Access Compliance Report

Public Rights-of-Way

(Curb Ramps)

Intersection ID: 29647	Main Street: BALLYSHANNON_LN	Cross Street: SOUTHERN_GARDEN_LN	Location: NE
ADA ID: 2F94BD736330	Ramp Type: PerpDiag	Initial Pass/Fail: Fail	Overall Compliance: No
Severity Score: 8.75			
Codes/Mitigation Info/Possible Solution		Field Measurements/Component Compliance

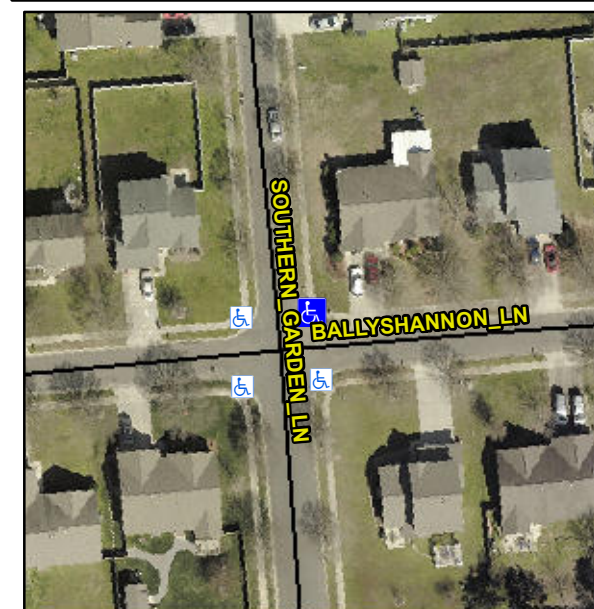
Not Found, R304.5.1

Compliance	Description	Data	Compliance	Description	Data
N/A	Ramp Length (in)	49.0	Yes	Ramp Slope (%)	7.4
No	Ramp Width (in)	36.0	Yes	Ramp XSlope (%)	0.1
N/A	Flare Type LT	N/A	N/A	Flare Type RT	N/A
N/A	Flare Slope LT (%)	N/A	N/A	Flare Slope RT (%)	N/A
N/A	Flare Traversable LT?	N/A	N/A	Flare Traversable RT?	N/A
N/A	Landing Length (in)	N/A	N/A	DWS Provided?	N/A
N/A	Landing Width (in)	N/A	N/A	DWS Contrast?	N/A
N/A	Landing Slope (%)	N/A	N/A	DWS Length (in)	N/A
N/A	Landing X Slope (%)	N/A	N/A	DWS Full Width?	N/A
N/A	Landing Curb? (Y/N)	N/A	N/A	DWS Offset (in)	N/A
N/A	Shared Landing?	N/A			
N/A	Gutter Ponding?	N/A	N/A	Gutter Slope (%)	N/A
N/A	Gutter Lip Ht (in)	N/A	N/A	Gutter X Slope (%)	N/A
N/A	Painted X Walk1?	No	N/A	Painted X Walk2?	No
	X Walk 1 Direction	To W		X Walk 2 Direction	To S
N/A	X Walk 1 Width (in)	N/A	N/A	X Walk 2 Width (in)	N/A
	X Walk 1 Slope (%)	4.3		X Walk 2 Slope (%)	3.6
	X Walk 1 X Slope (%)	1.6		X Walk 2 X Slope (%)	0.4

Remove & Replace Curb Ramp With Two New Directional Ramps or Equivalent.
